Attachment A

Revise the Technical Specification pages as follows:

## Attachment B

By submittal dated December 20, 1983 Rochester Gas and Electric provided to the NRC a Reload Transition Safety Report (RTSR) which identified the results of a reanalysis of FSAR Chapter 15 design basis events for the transition to a full core of Westinghouse OFA fuel. This analysis assumed a steam generator tube plugging level of 10 percent for non-LOCA events, and 12 percent for LOCA.

FIGURE 2.1-1  
CORE DNB SAFETY LIMITS  
2 LOOP OPERATION

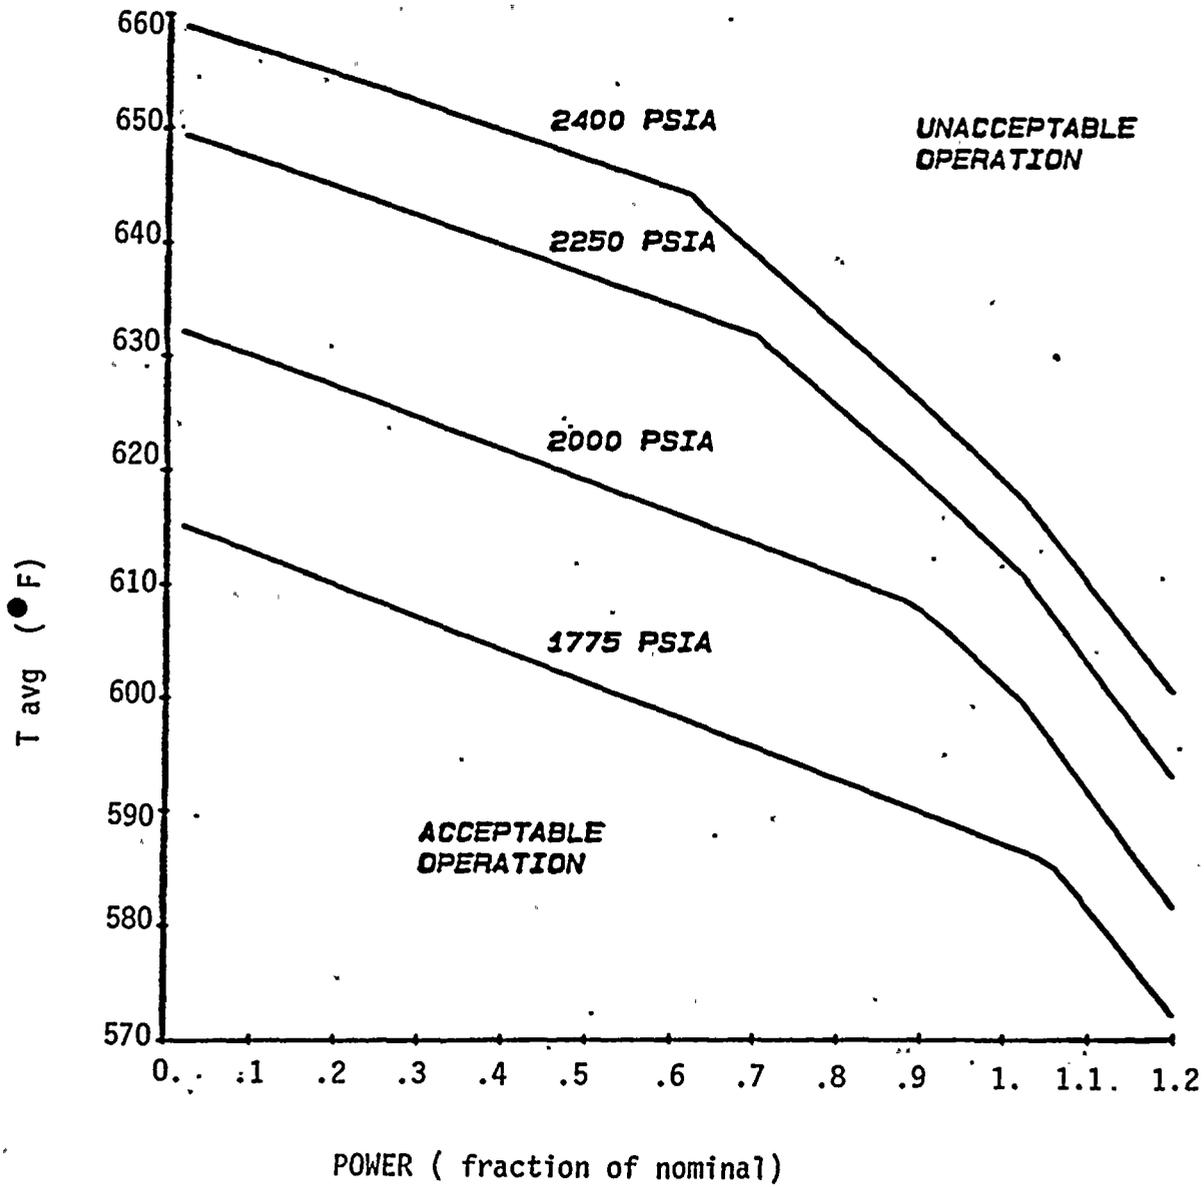
1. Figure 2.1-1, Core DNB Safety Limits have been changed reflecting the 2.2 percent reduction in the RCS thermal design flow with the higher level of tube plugging.
2. The Overtemperature and Overpower Delta T setpoints have been changed to provide protection for the adjusted Core DNB Safety Limits.
3. Miscellaneous changes to the bases to incorporate an updated description and references.
